CITY OF NEWARK

ADDENDUM #2

Name: City Hall Parking Lot Reconstruction

Contract Number: 23-07

CONDITIONS PLAN

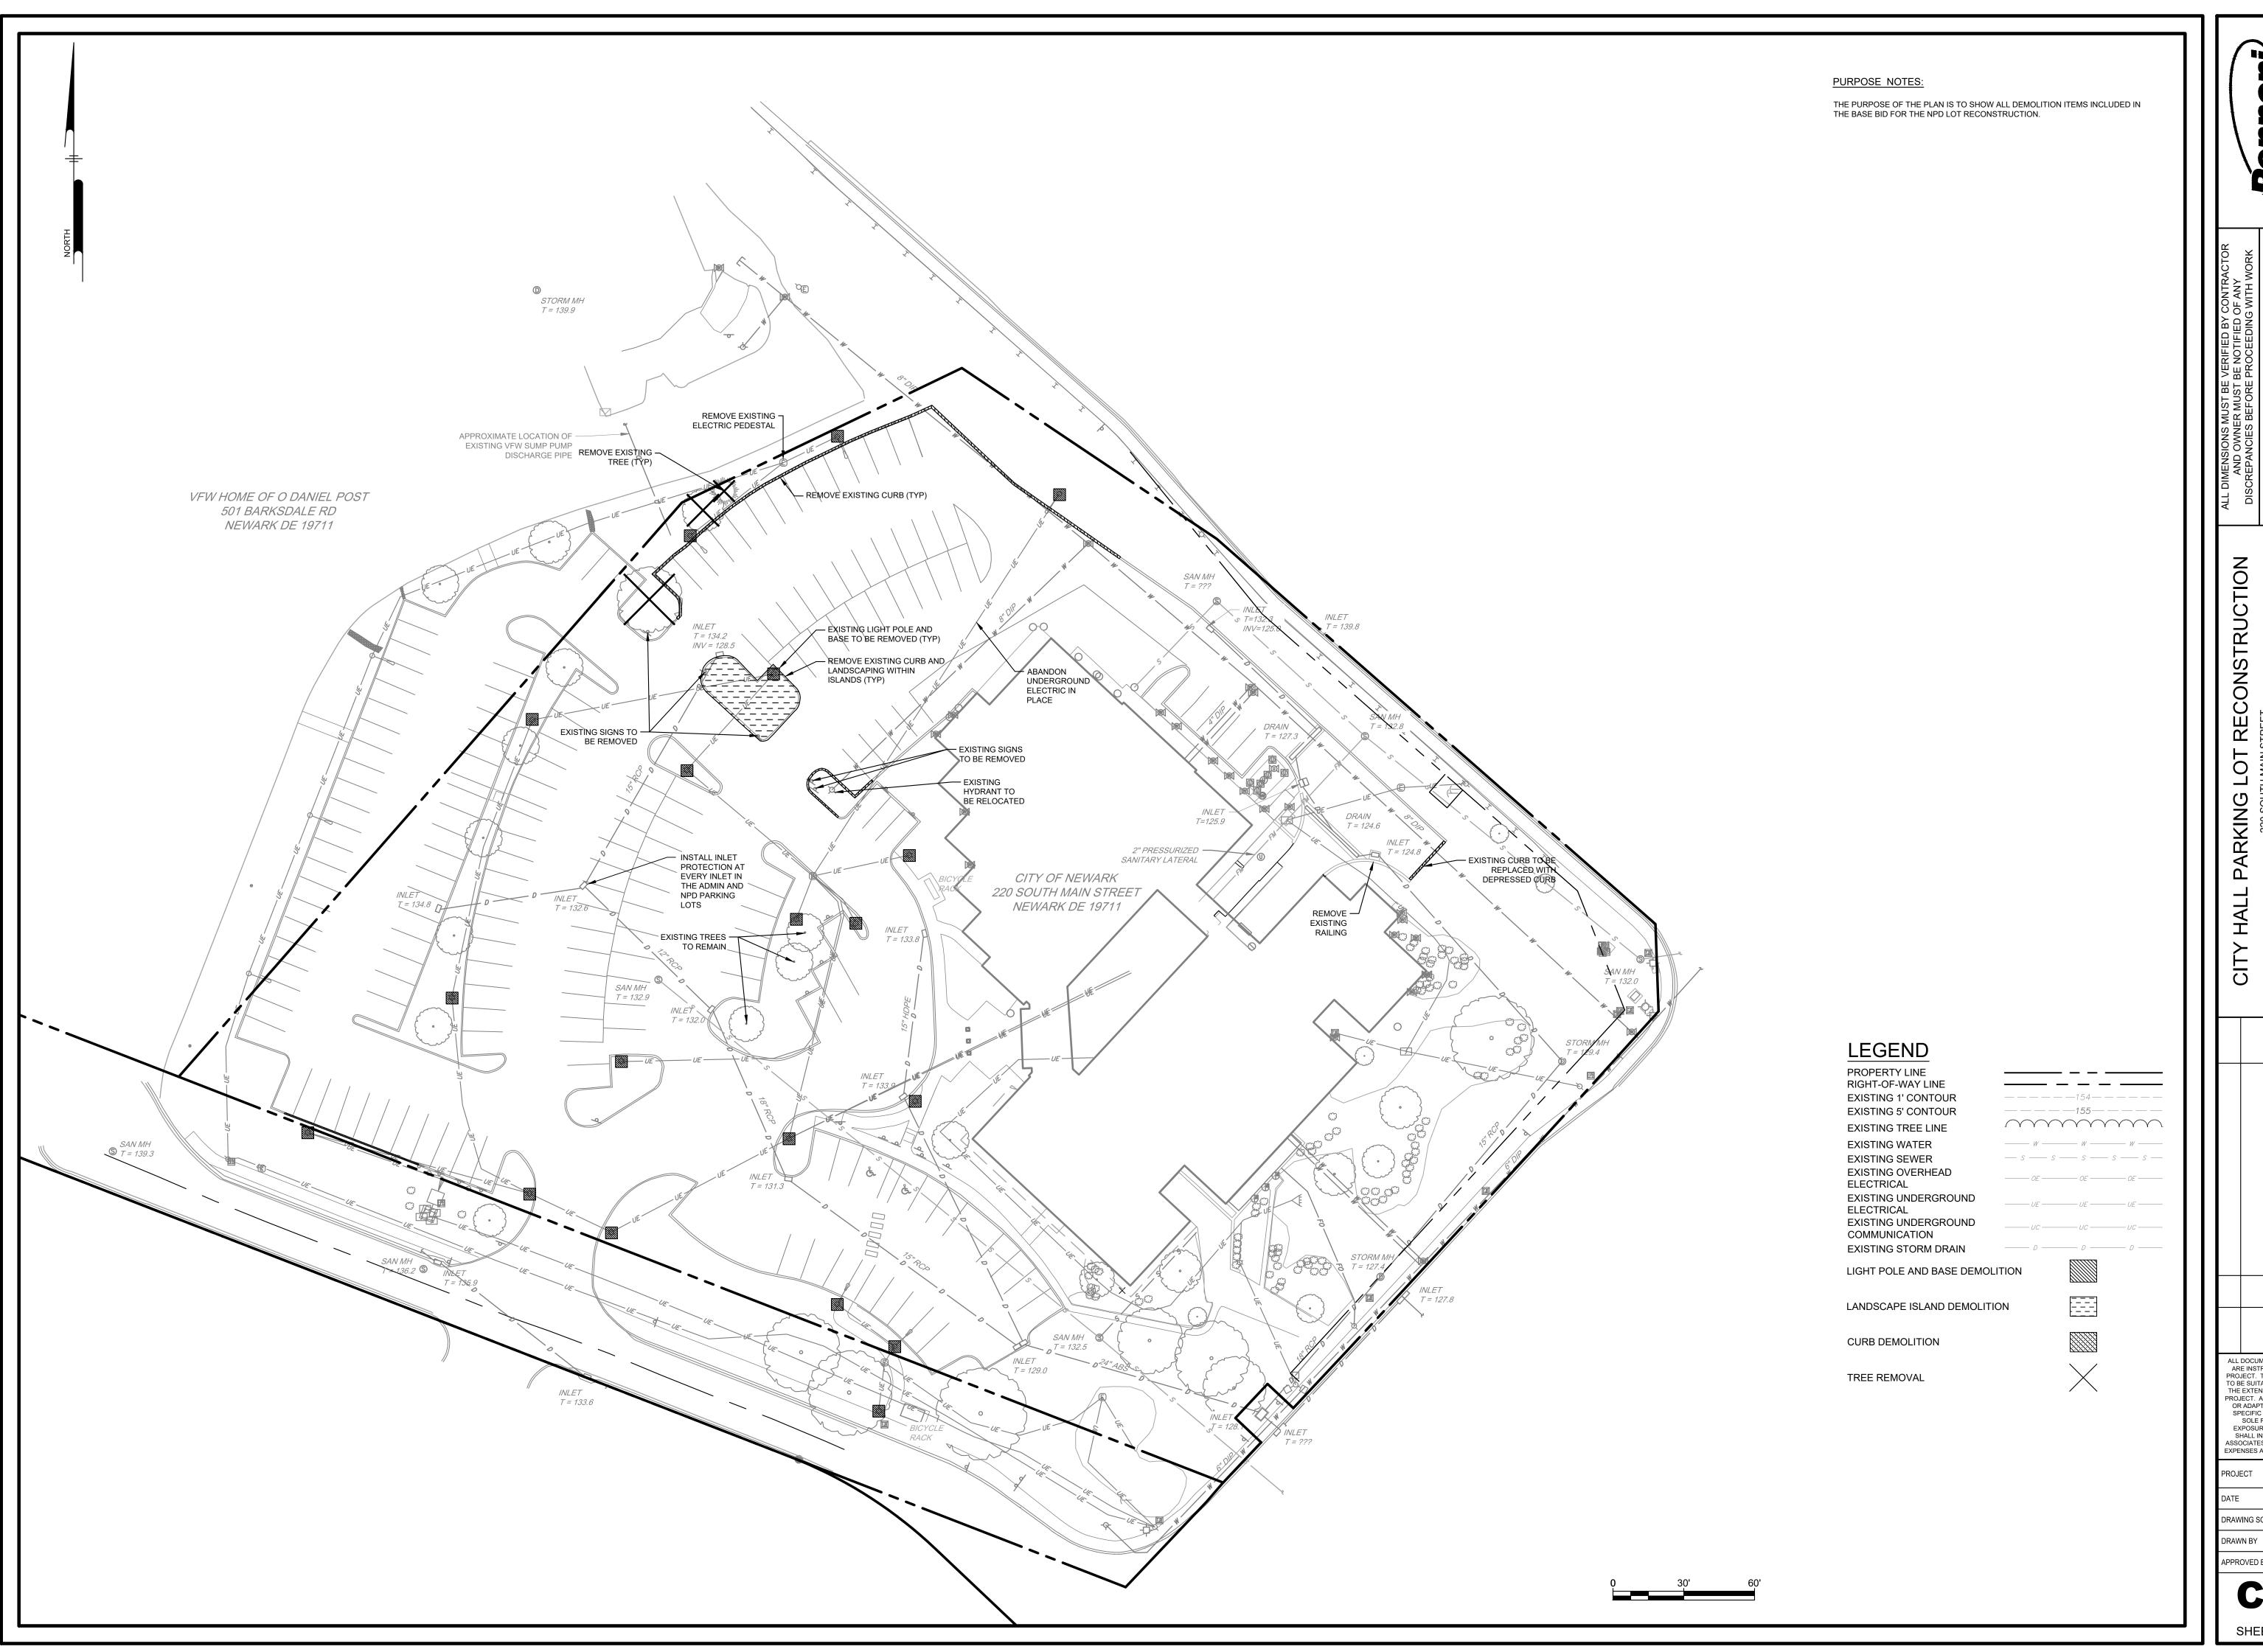
- Q. Where is the right of way for Apple Road and are there any impacts to the construction area?
- A. The Right of way has been added to the plan and no there are no impacts to the construction area.
